**URGENT FIELD SAFETY NOTICE**

**Name of product affected: ... Anaconda and Anaconda ONE-LOK™ Stent Graft Systems**

**FSCA identifier: CAPA 162**

**Type of Action: ... Additional instructions to enable the bifurcate body delivery system to be safely withdrawn after being fully deployed.**

**Schematic 2: Guidewire passing through control loop.**

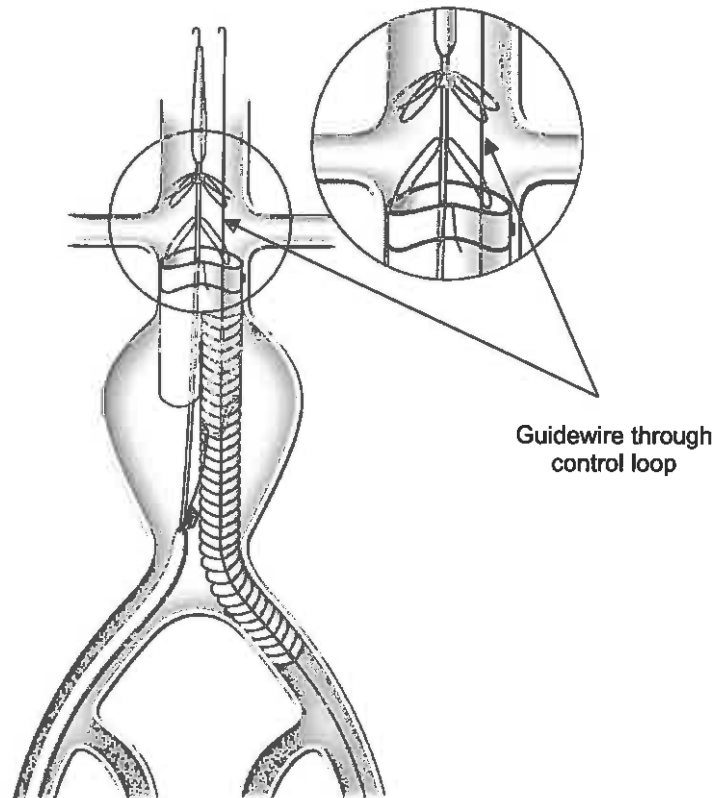
Upon advancement of the guidewires the Intrinsic magnet wire may pass through one of the control loops. As a result, when the Intrinsic magnet wire is withdrawn, the remaining contralateral guidewire, catheter and/or balloon will also have passed through the same loop of the body delivery system, as indicated in Schematic 2. On attempting to remove the bifurcate body delivery system from the ipsilateral lumen, it will be found it cannot be withdrawn. The loops which are tied to the body delivery system are being held by the contralateral guidewire, catheter and/or balloon in the contralateral lumen, above the bifurcate flow splitter.

**Schematic 3: Retracting guidewire.**

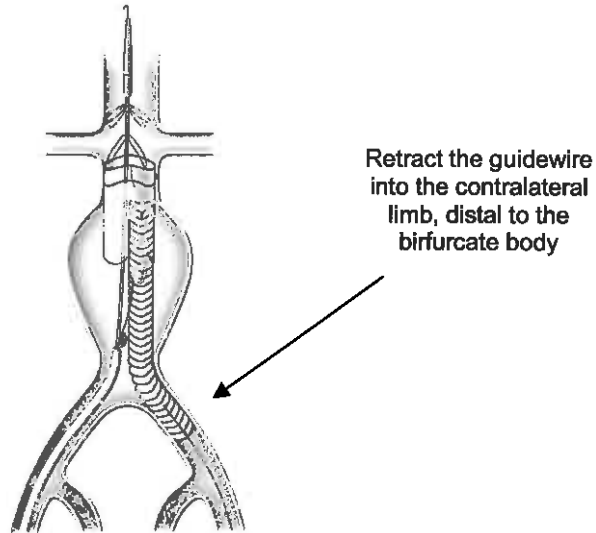
To help prevent further occurrences, if difficulty is experienced in removing the bifurcate body delivery system, the following action as presented in Schematics 3 and 4 is recommended:

Carefully retract any contralateral guidewire, catheter and/or balloon until their tips are within the iliac leg stent graft but distal to the contralateral stump of the bifurcate body as illustrated in Schematic 3.
